# 1984 - 1985 Corvette: Service Bulletin: Door Ajar Switch Corrosion

**Subject:** Door Ajar Switch Corrosion

**Bulletin Number:** 85-43, Number 8B (XII) & 10(I)

**Date:** Feb., 1985

- REPLACEMENT 14087681 DOOR AJAR SWITCH  
(WITH SLEEVE)

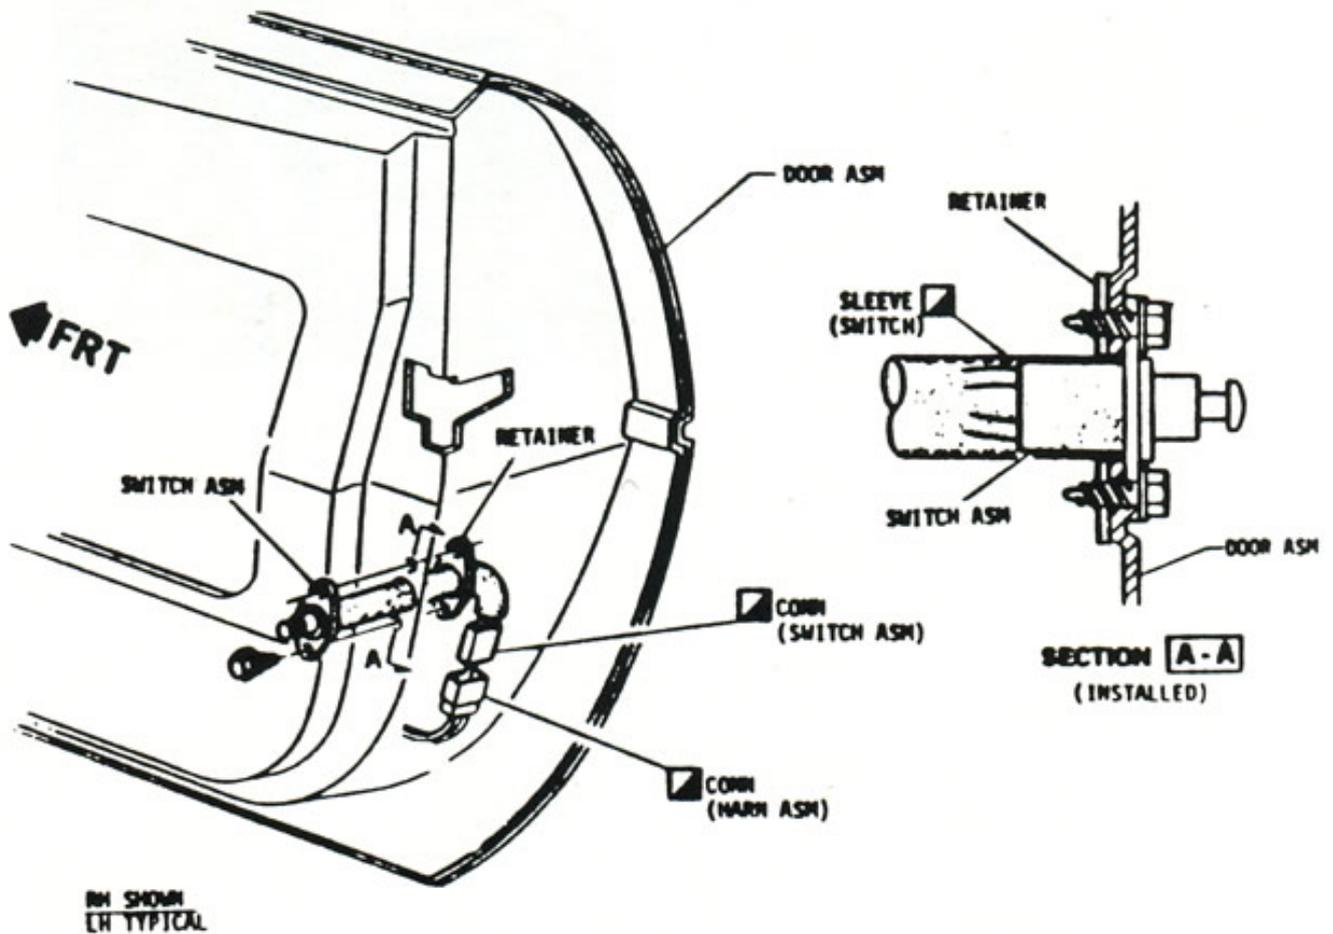
SOME 1984 AND EARLY PRODUCTION 1985 CORVETTE DOOR AJAR SWITCHES (P/N 14062556) MAY BECOME INOPERATIVE DUE TO INTERNAL CORROSION. THIS CAUSES THE DOOR AJAR LIGHT TO EITHER BECOME INOPERATIVE, FLICKER, OR STAY ON.

A NEW CORROSION RESISTANT SWITCH (P/N 14087681) AND AN ASSOCIATED RETAINER (P/N 14087682) ARE TO BE USED AS SERVICE REPLACEMENTS. THE NEW SWITCH INCLUDES A SLEEVE (SEE ILLUSTRATION) THAT FITS TIGHTLY AROUND THE SWITCH'S HOUSING AND HAS SUFFICIENT LENGTH TO COVER THE WIRE CONNECTOR ONCE CONNECTION TO THE DOOR HARNESS IS MADE.

WHEN REPLACING THE EXISTING SWITCH WITH A NEW 14087681 SWITCH, THE DOOR INSERT HOLE WILL NEED TO BE ENLARGED FROM 16MM TO 18MM TO ACCOMMODATE THE SLEEVE PROVISION. CARE MUST BE EXERCISED WHEN ENLARGING THE INSERT HOLE SO THAT ADJOINING MOUNTING HOLES ARE NOT ALTERED. SCRATCHES, CHIPS, ETC., TO DOOR PANEL SURFACE RESULTING FROM THE HOLE ENLARGING PROCESS ARE TO BE COSMETICALLY REPAIRED AS OUTLINED IN SECTION 10 (BODY) OF THE CORVETTE SHOP MANUAL.
